Project: **NYC Police Memorial Vault
Conditioning And Storm
Protection Design Project**

RE: **Addendum #2**
of Pages: **13**

ATTACHMENT #1A
PLUMBING PLAN DRAWING P.1
FROM POLICE MEMORIAL'S
ORIGINAL DESIGN DRAWINGS

DRAWING TITLE:
PLUMBING PLAN

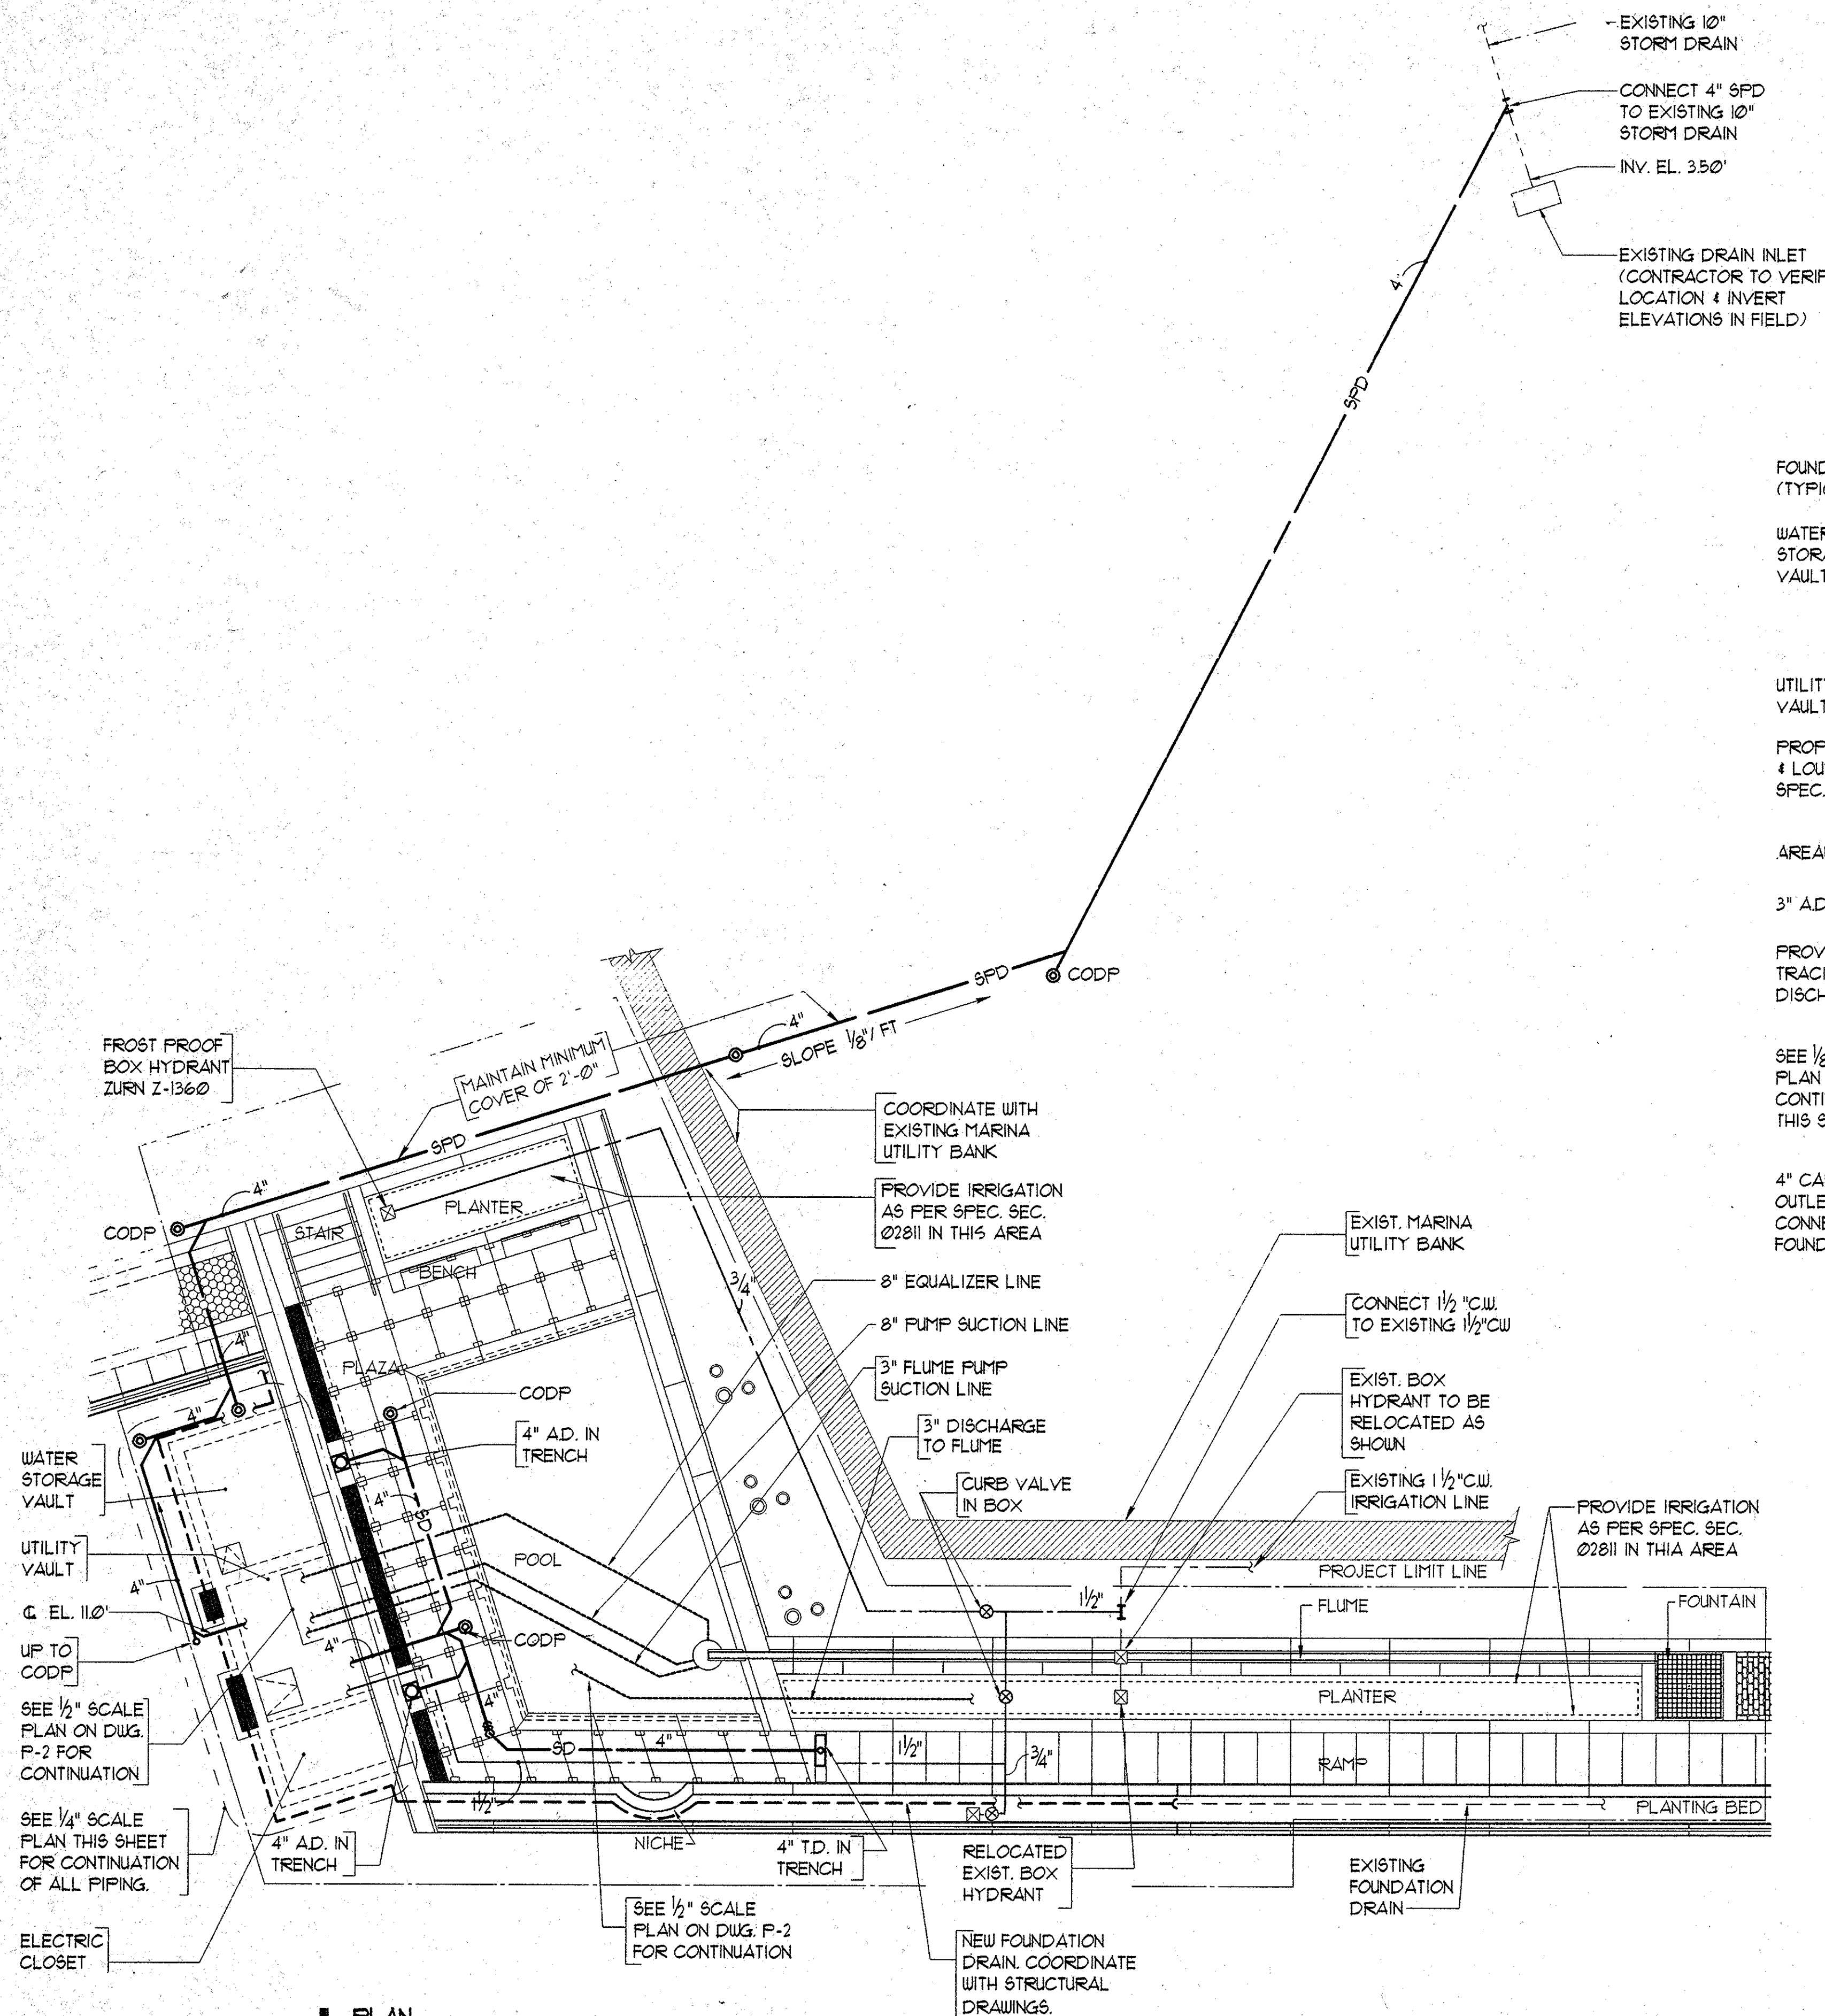
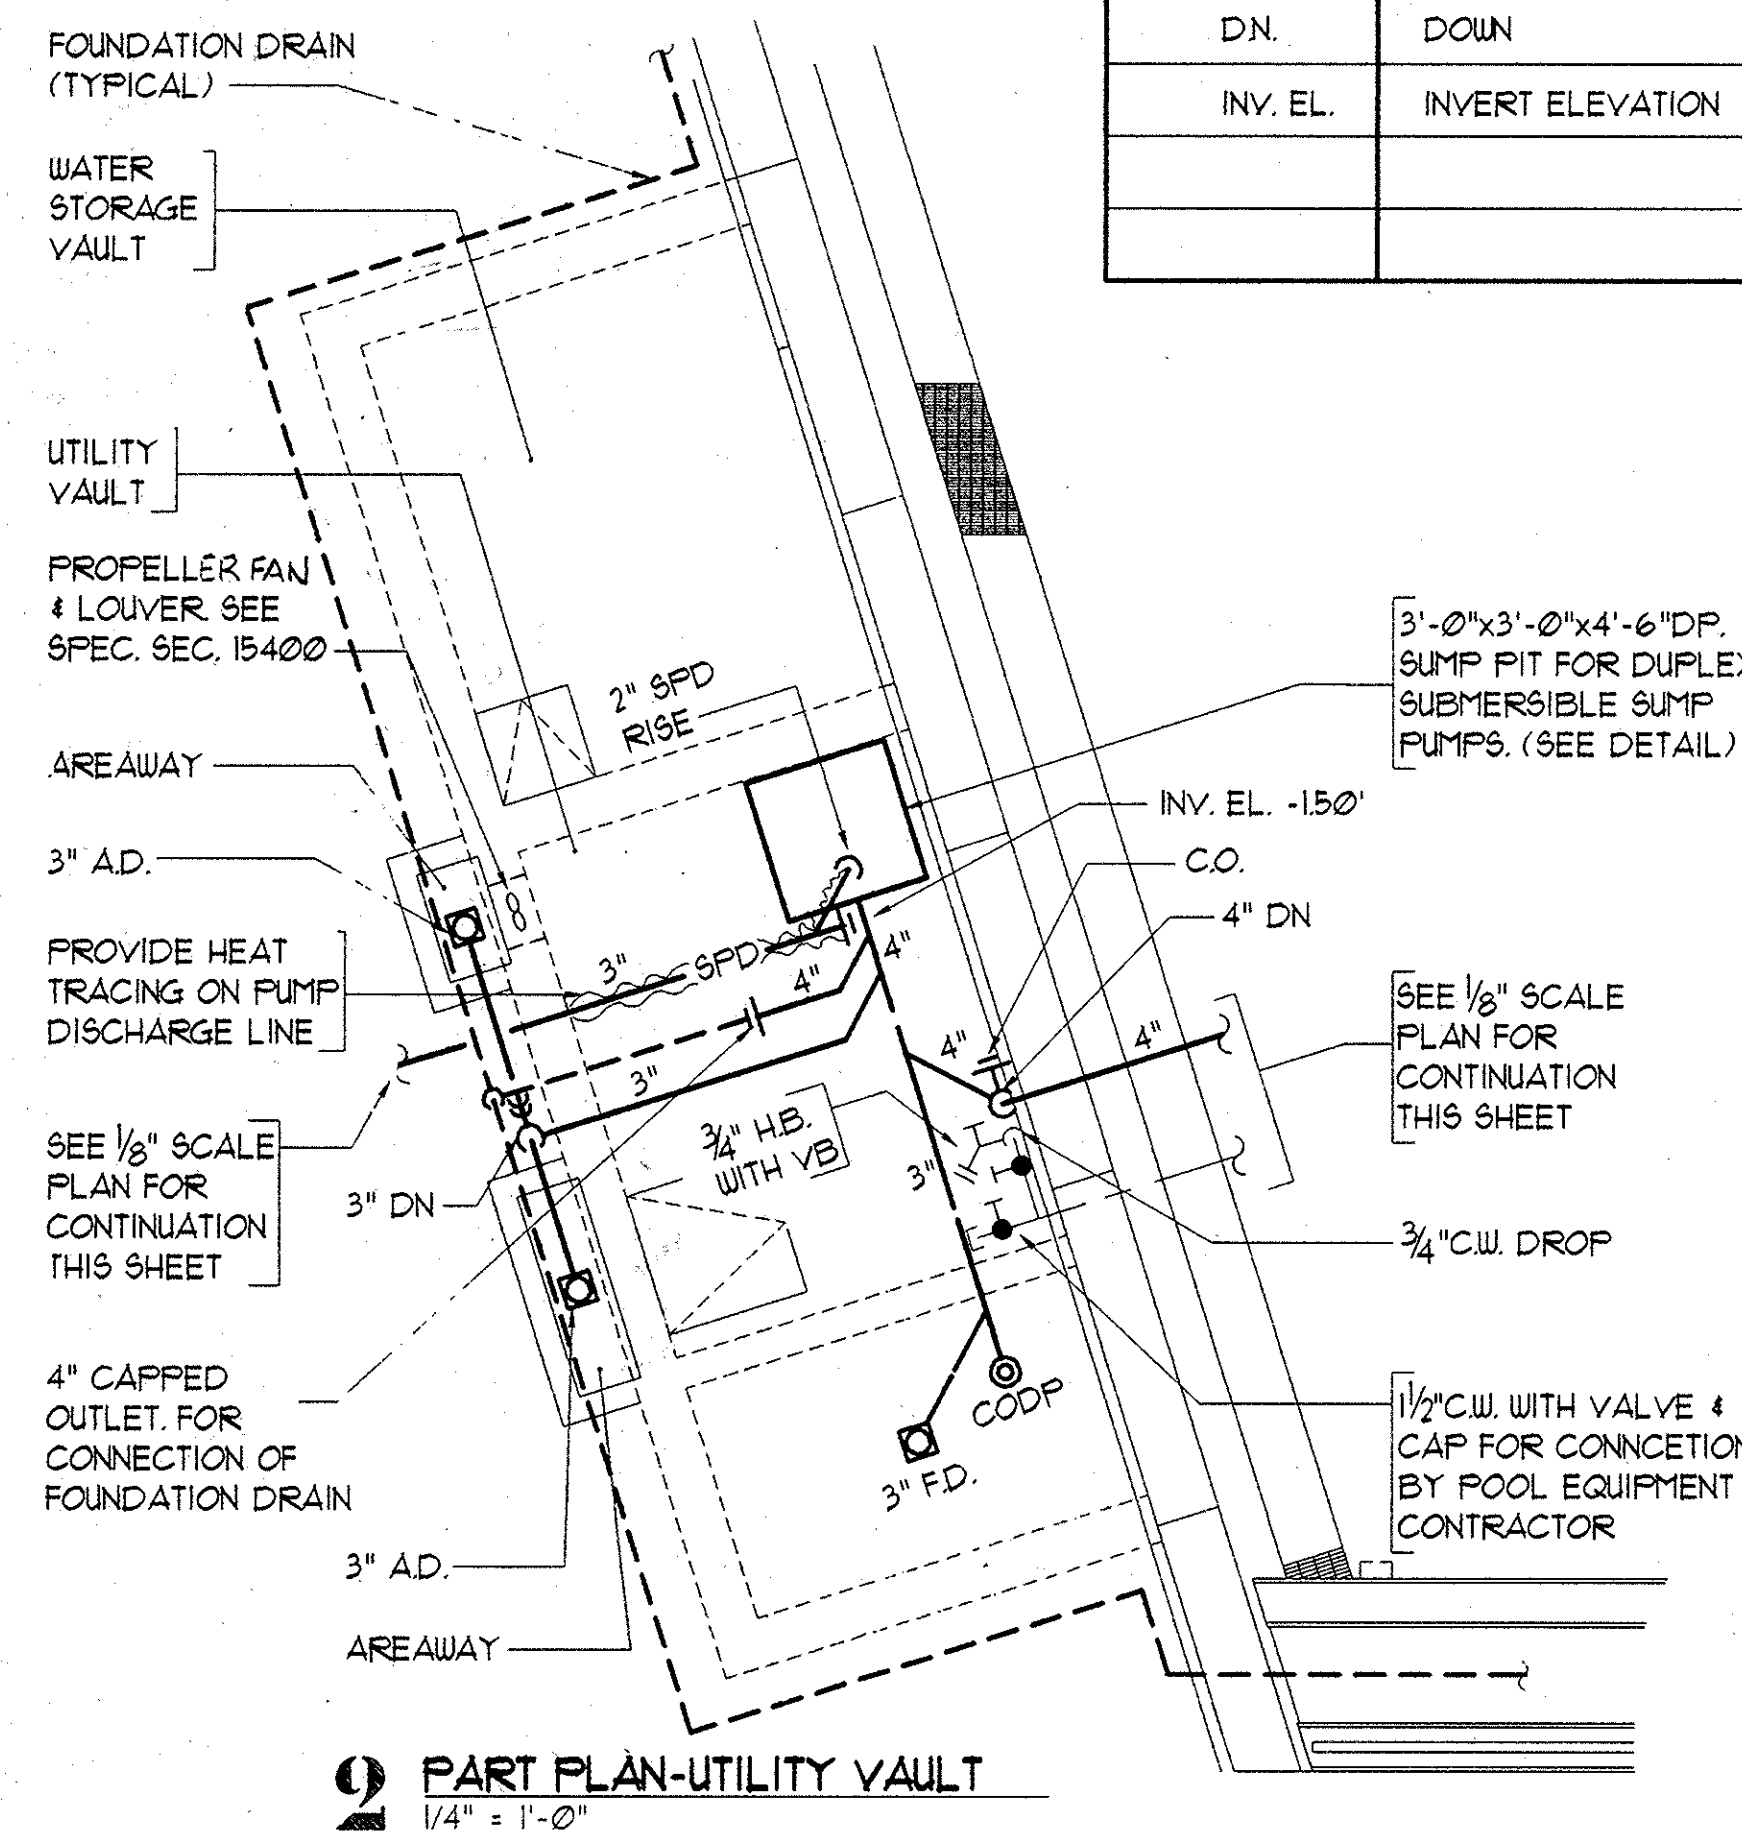
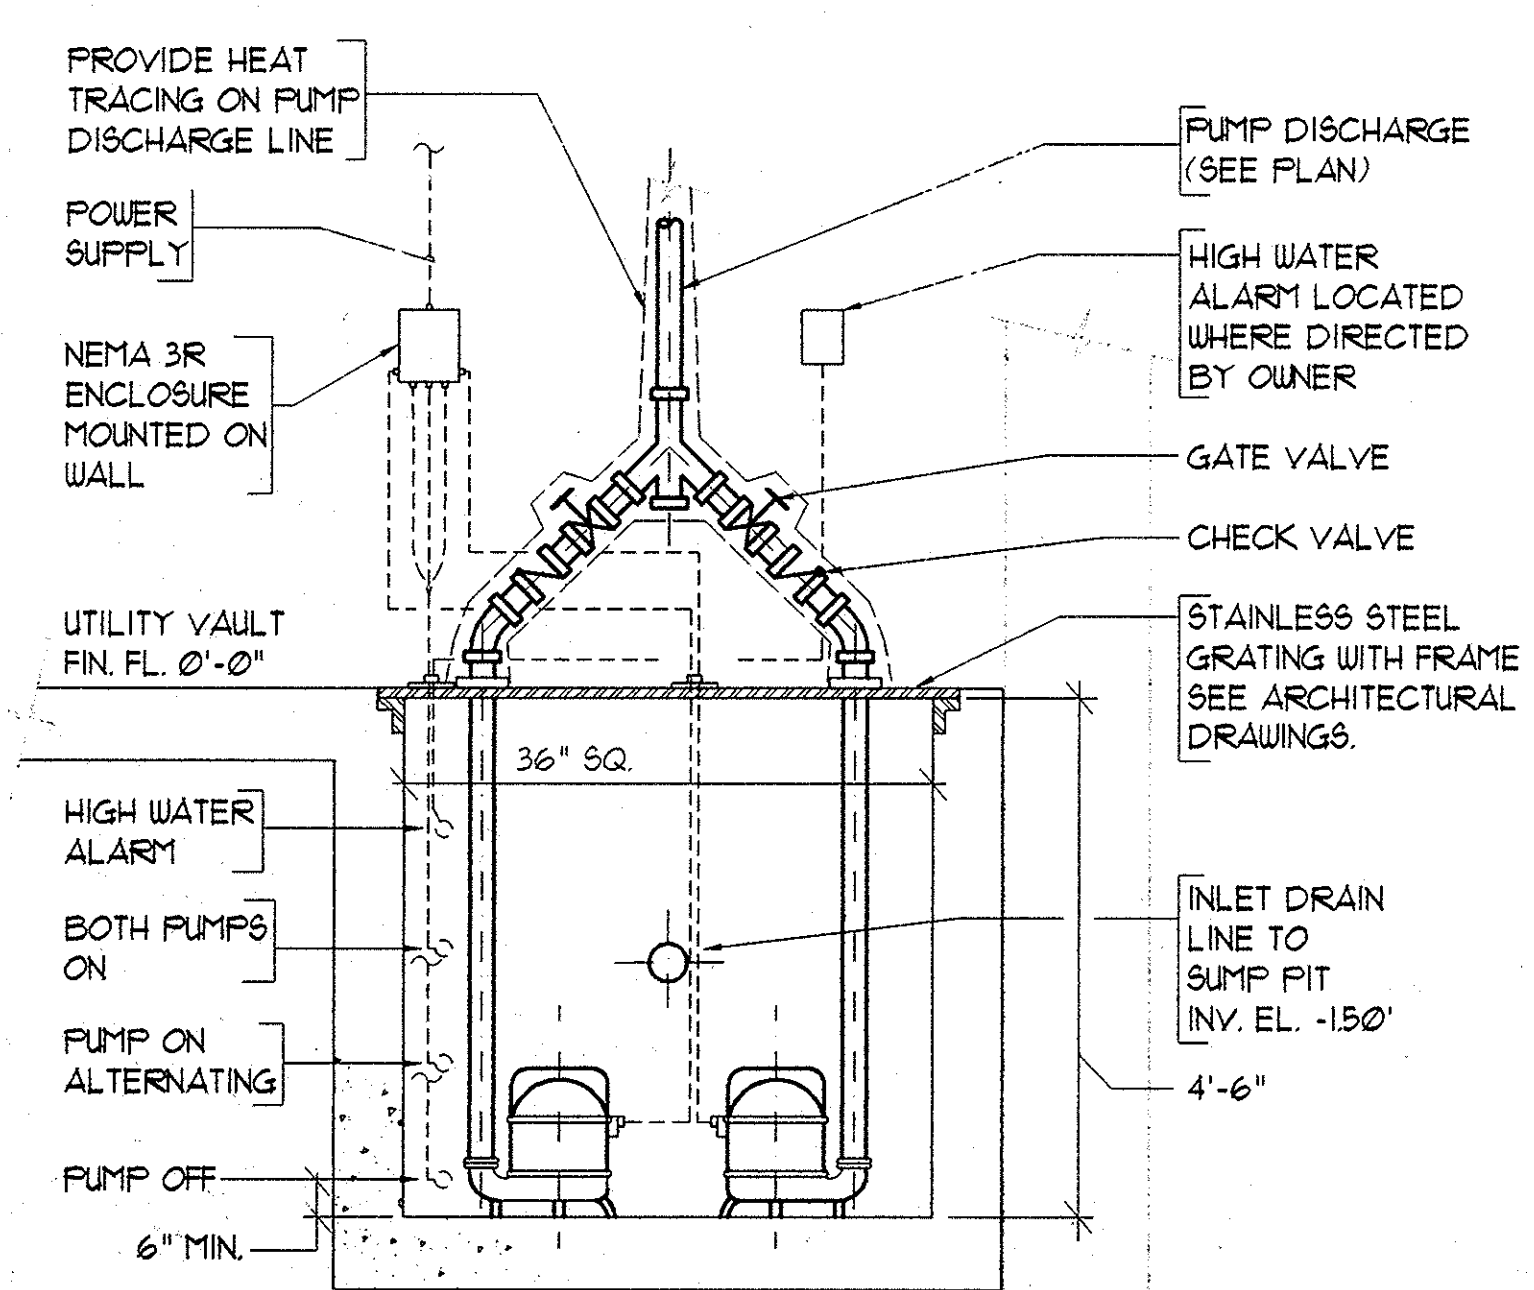
1. Will BPCA provide existing drawings detailing the construction of the vault and basin along with all associated equipment and controls? ***Please see Attachments #1A and #1B.***

6. Will the project be permitted? **Yes**
7. How big is the vault? **As shown in the Police Memorial's original design drawings – provided, for reference purposes, as Attachment #3B to Addendum #1, and Drawing P1 is re-attached hereto as Attachment #1A – the Vault's electrical closet is 8' 8" (L) x 5' (W) x 12' (H), the utility vault is 8' 8" (L) x 11' (W) x 12' (H).**

9. Are there any drawings and/or photos inside the vault that can be shared? **Please see Attachments #1A and #1B.**
10. The Minority Business Enterprise/Women Business Enterprise (MBE/WBE) Utilization Plan form states, "Please attach copies of the most recent New York State Certification Letters for all MBE/WBE Firms Listed on this Utilization Plan." Can a copy of MBE/WBE or SDVOB certification be provided instead of the letter? **Yes, that is acceptable.**
